Facility Impact and Funding Committee (FIFC) Report

Charges of FIFC

Review list

K1.8BR

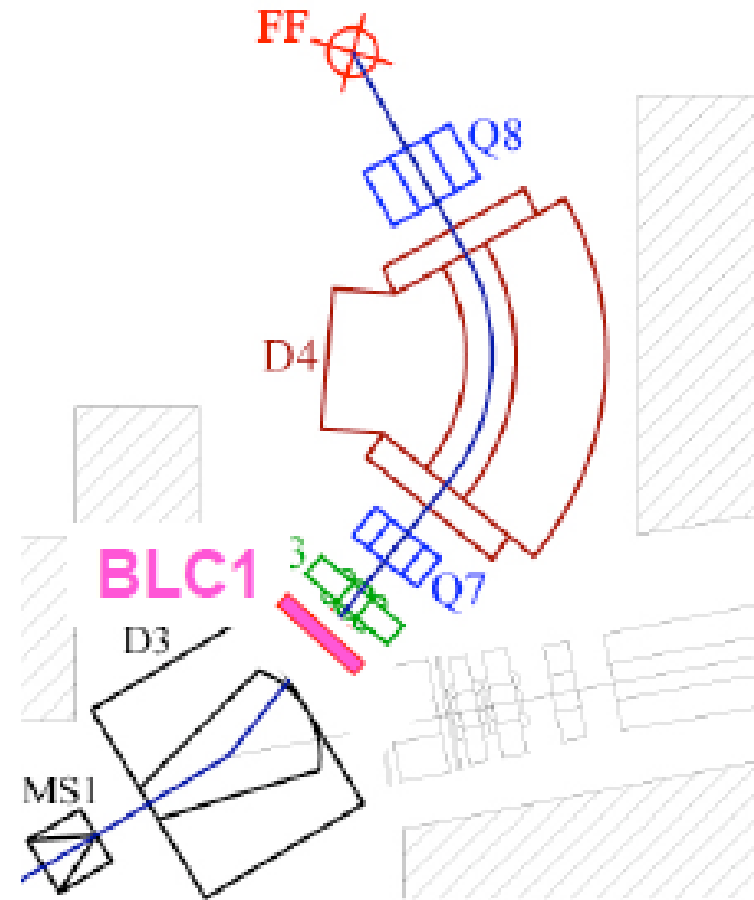
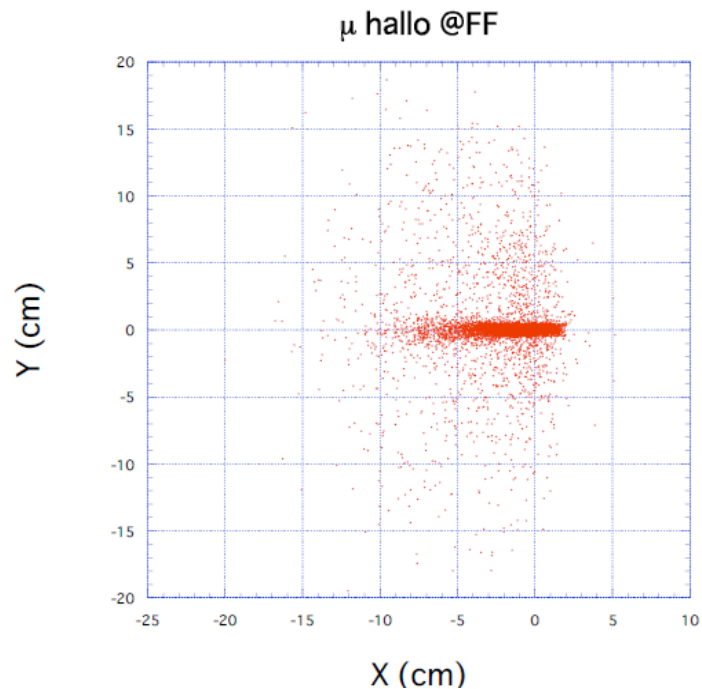
- Low mom. K line with a single Separator
- $K/\pi \sim 12$
 - Could be smaller (~ 3 in the independent simulation)
- Possible halo of μ
 - $1.5 \times K$

SKS+ Spectrometer

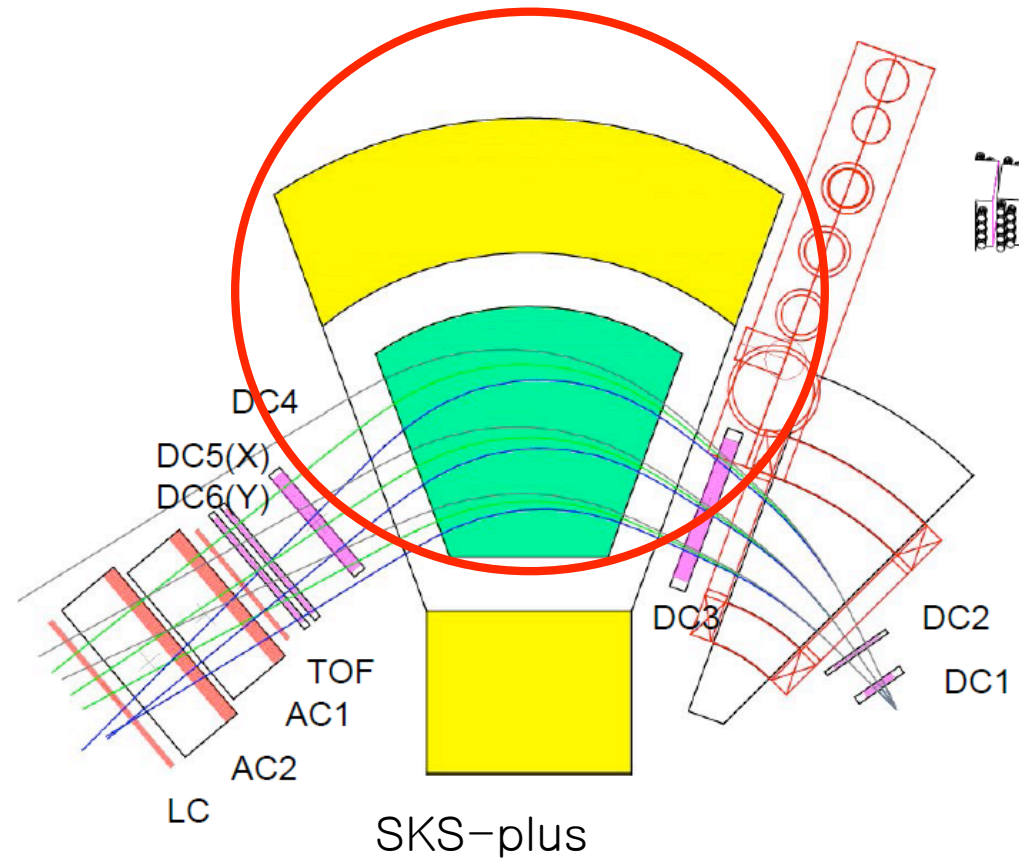
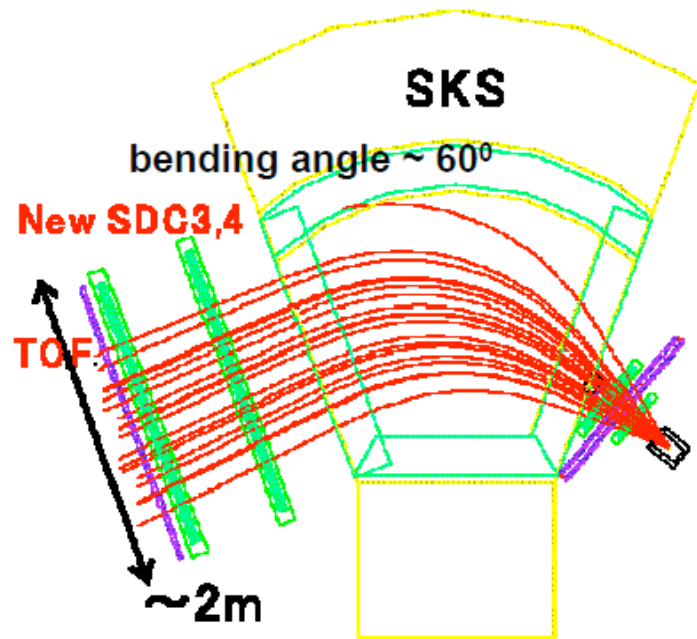
- Good experiences with SKS for many years.
 - Cryogenic system will become simpler and more portable.
 - Organized activity to design/optimize, construct and maintain the system including the beam line spectrometer as a *common facility* is needed. It might help to reduce the cost of the experiments.
-

Gamma-ray spectroscopy of light hypernuclei

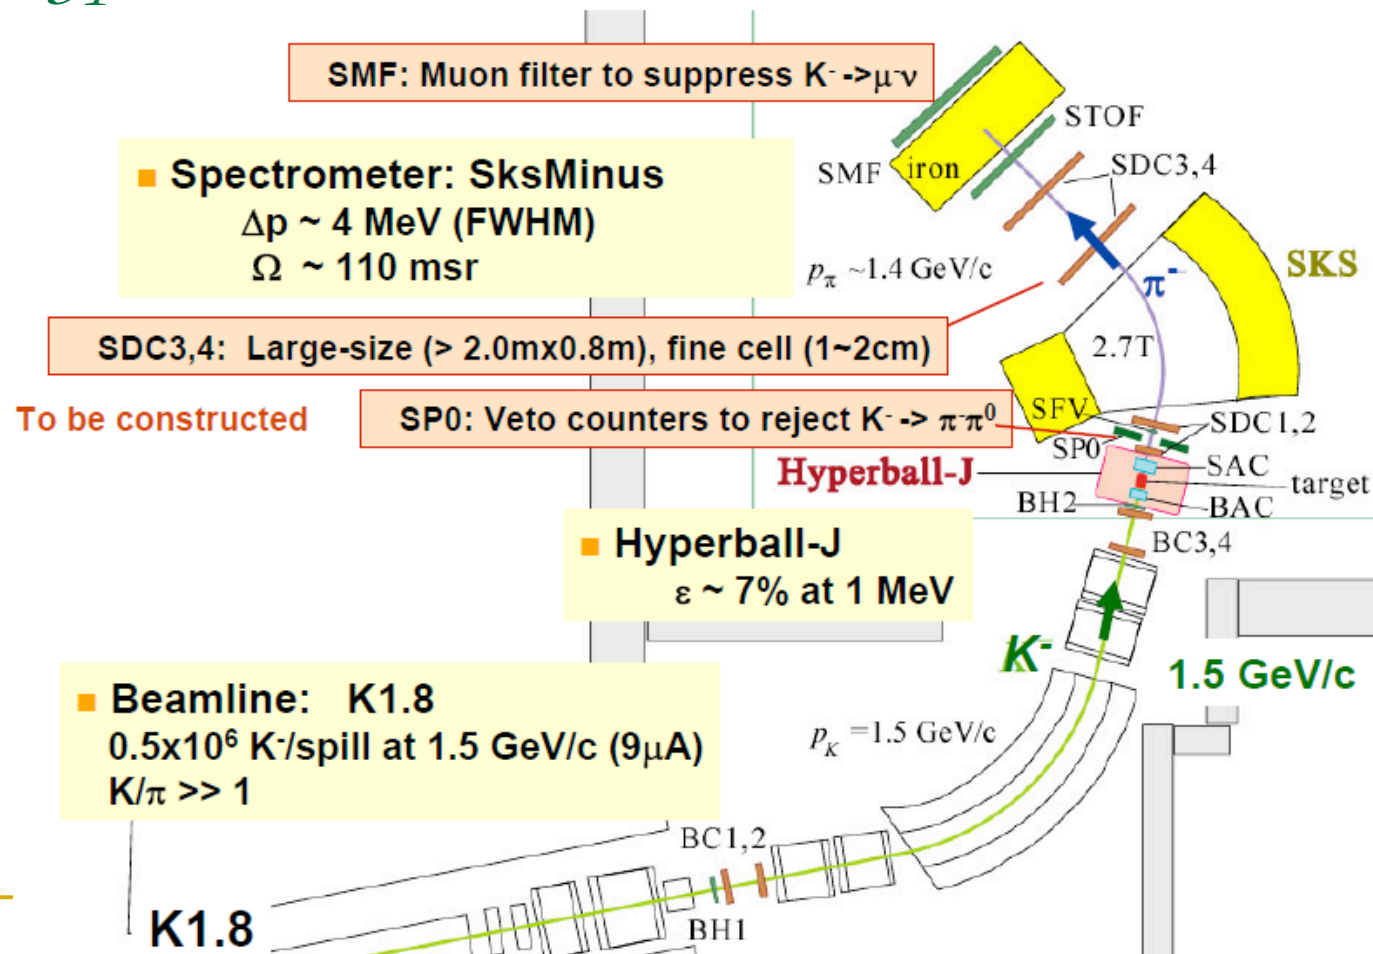
- SKS- with a wider acceptance/larger chambers of 100 μ m resolution downstream.
 - More Ge detectors operated at hopefully lower temperature.
 - Encourage to continue the effort for the development of a special refrigerator/cryostat/connection.
 - PWO replaces BGO as a Compton shield.
 - FIFC not fully convinced of its predominance.
 - An in-kind contribution from foreign institutes for the downstream chambers should be appreciated.
-

High-resolution Search for Θ^+ Pentaquark in $\pi p \rightarrow K X$ Reactions

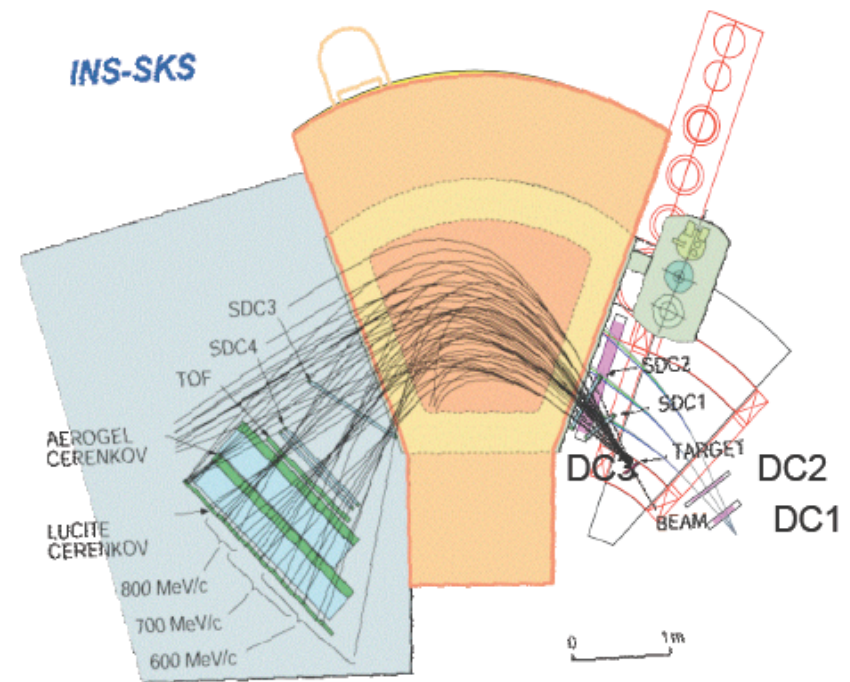
- Detector rate capability will limit the π beam intensity. Its improvement is essential for the experiment sensitivity.
- SKS be used.
 - Better MM resolution than PS-E522.
 - 25% of acceptance with SKS+
- No concern on Liq. Hydrogen target
 - Same equipment used in KEK-PS
 - Should be inspected under the regulation in J-PARC
- What is the goal sensitivity?

Systematic Study of Double Strangeness Systems with an Emulsion-counter Hybrid Method

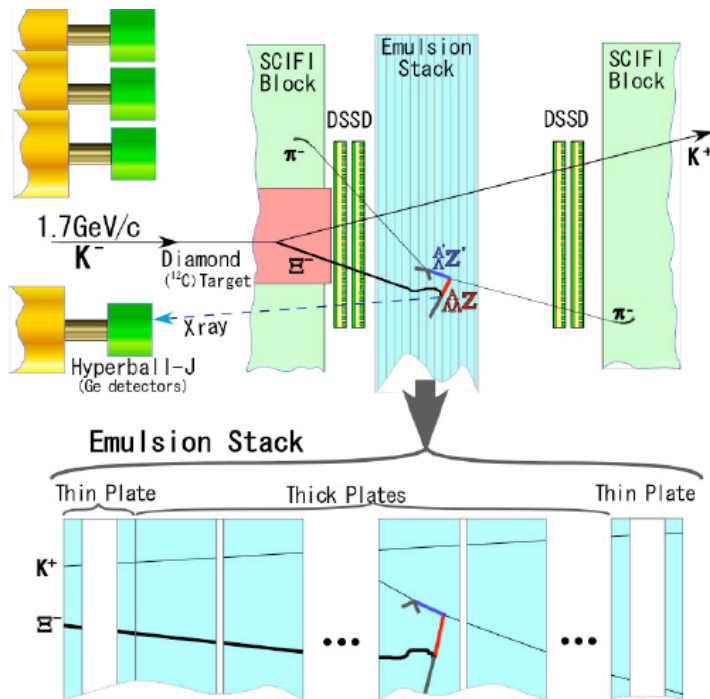
- Technology established well in KEK-PS. 10 times more statistics is aimed at.
- DSSD will be newly adapted.
 - Alignment strategy might be important for an efficient scanning.
- USE of KURAMA magnet is twice effective than SKS and preferable.

A Search for deeply-bound kaonic nuclear states by in-flight ${}^3\text{He}(K^-, n)$ reaction

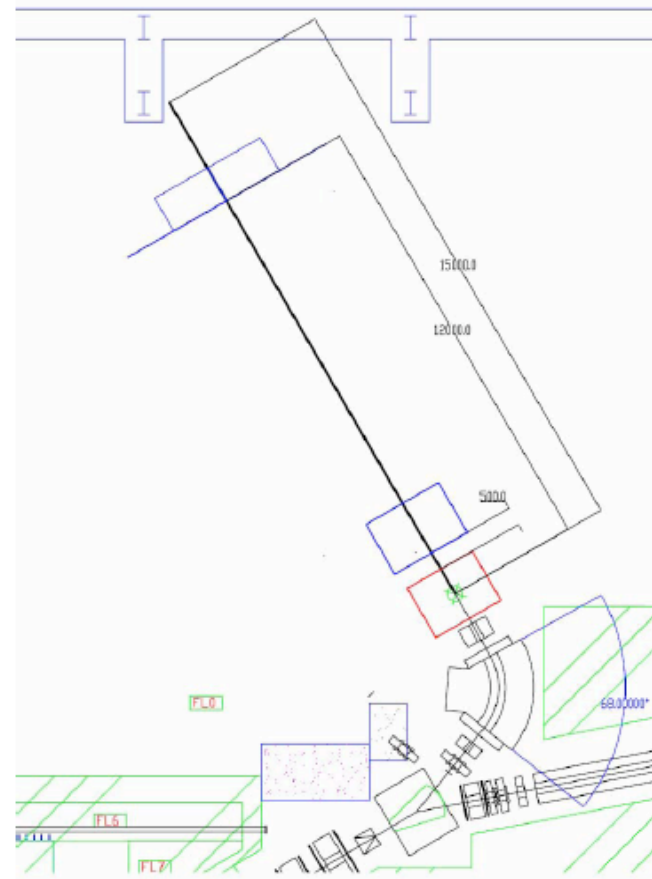
- 1GeV/c K beam@ K1.8BR
 - K/ π ratio could be worse than expected.
 - μ halo (1.75xK) should be investigated
- Flight length for neutron TOF
 - Barely fit in the exp. Hall.
- Sweep magnet
 - Wide gap Ushiwaka can be applied.
- Liq. ${}^3\text{He}$ target
 - Effective heat conductance should be checked with ${}^4\text{He}$ as scheduled in this JFY.
- New solenoid magnet (to be delivered soon) & CDC/CDH

Precision Spectroscopy of Kaonic ^3He $3d \rightarrow 2p$ X-rays

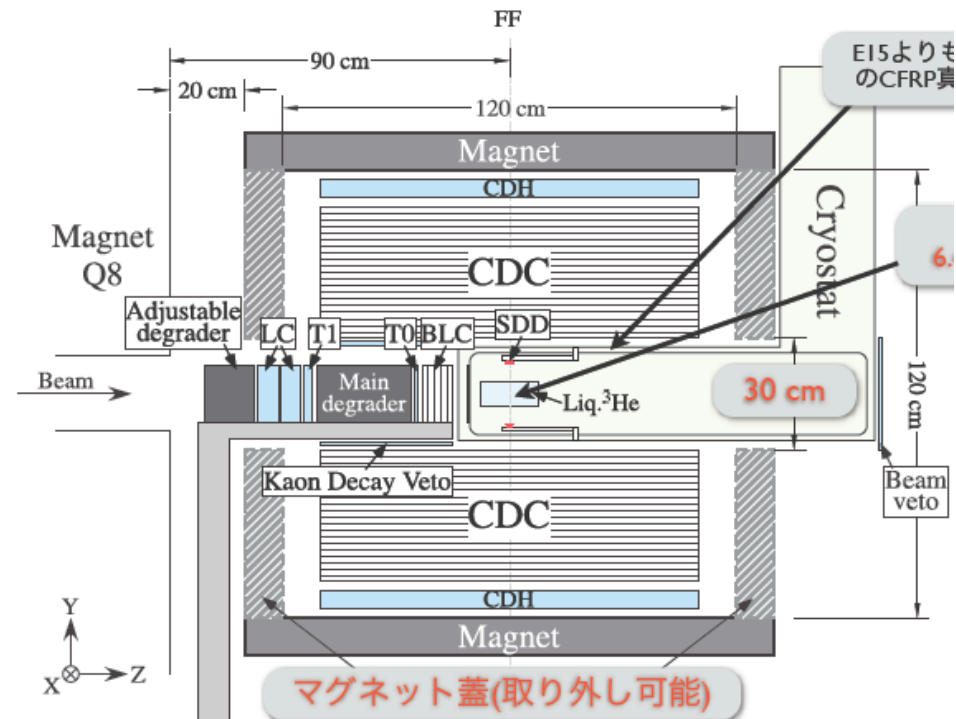
- X ray detection by low noise SDD
- Systematics might be an issue even with the in-situ calibration by Ti/Ni $K\alpha/\beta$ lines.
- Check if the possible intense μ halo is not a problem. (for SDD nor BeamVeto)

Beam line detector

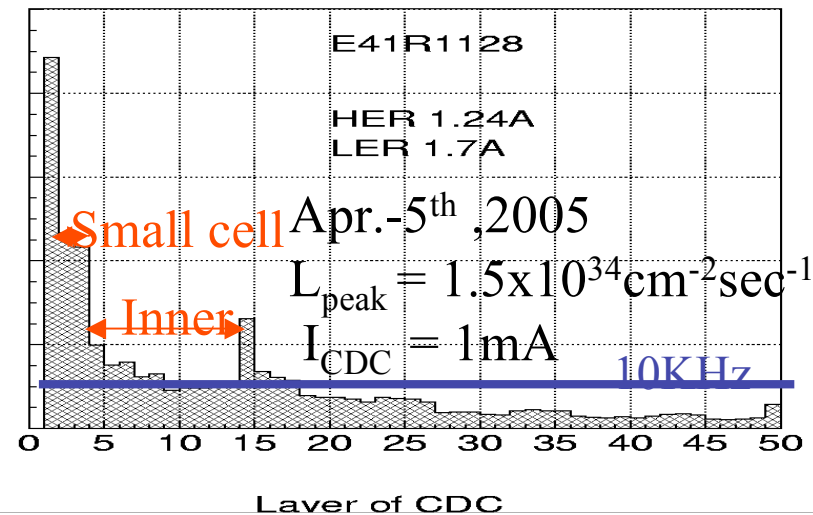
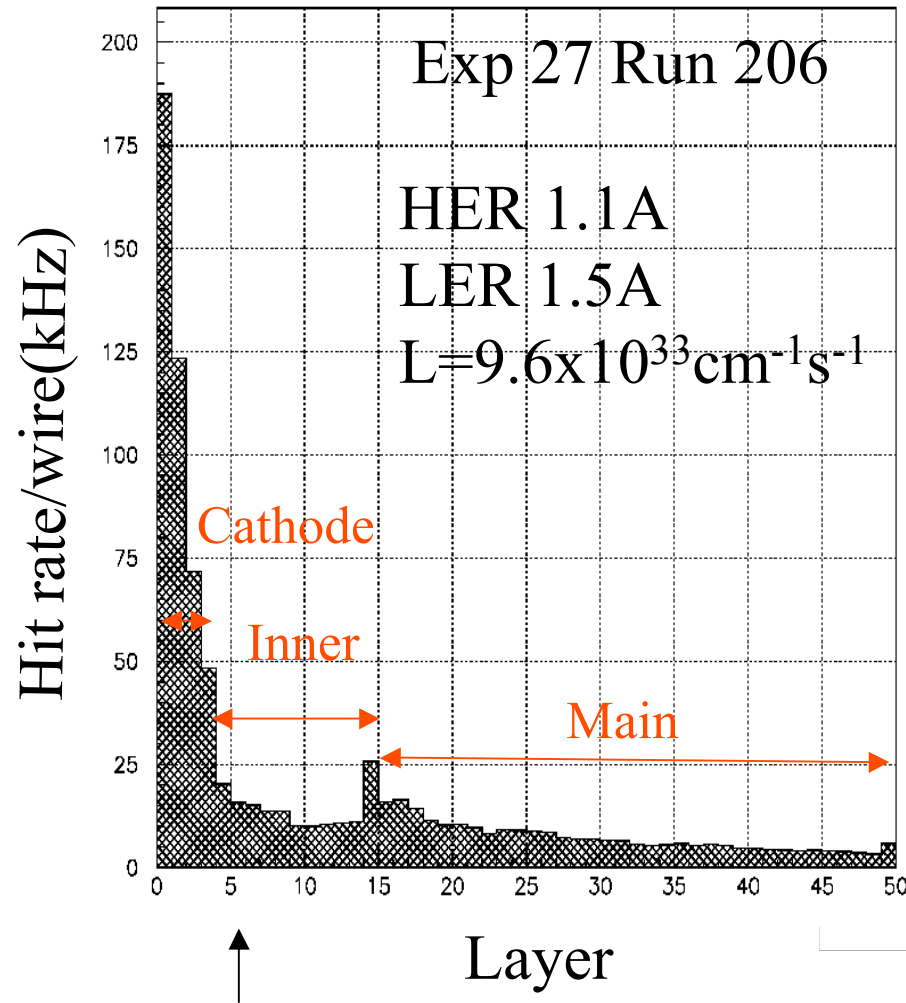
- The limitation of the detector may appear even in Phase I operation.
 - Life time is another concern.
 - Intensive R&D for the detector with higher capability should be started. GEM tracker or thinned-Si strip may be a solution.
-
